McCULLOCH

SERVICE BULLETIN # 1095

MODEL 1-70, 1-80, S44A, S44, S55A, S55

SUBJECT NEW COIL AND TERMINAL ASSEMBLY P/N 55683

Figure 1.

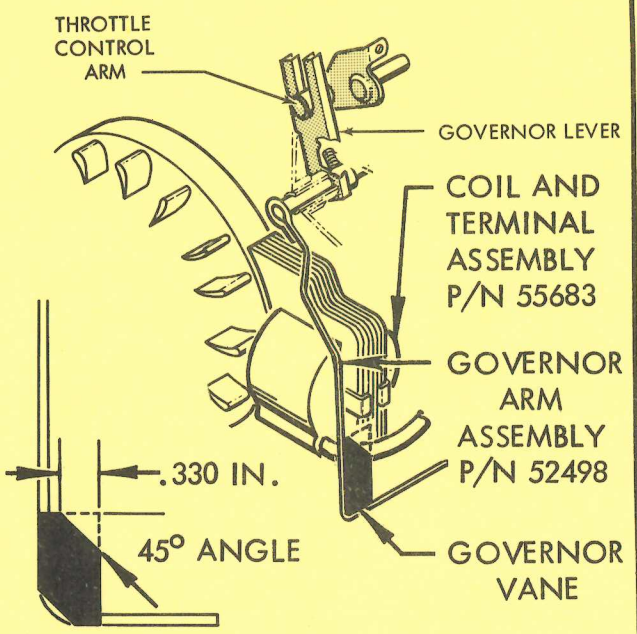
When installing the new Coil and Terminal Assembly on saws which contain the earlier 52498 Governor Arm Assembly, cut off one corner of the governor vane as shown in Figure 1. This will prevent interference between the governor vane and the coil housing.

Figure 2.

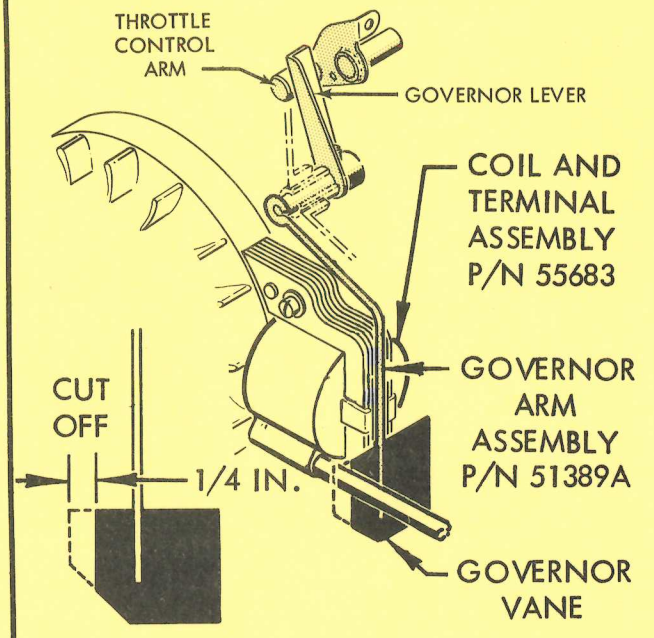
Model S44 and S55 engines contain a 51389A Governor Arm Assembly, which has a different vane than the one used on the 52498 Assembly. Cut off 1/4-inch of the vane as shown in Figure 2.
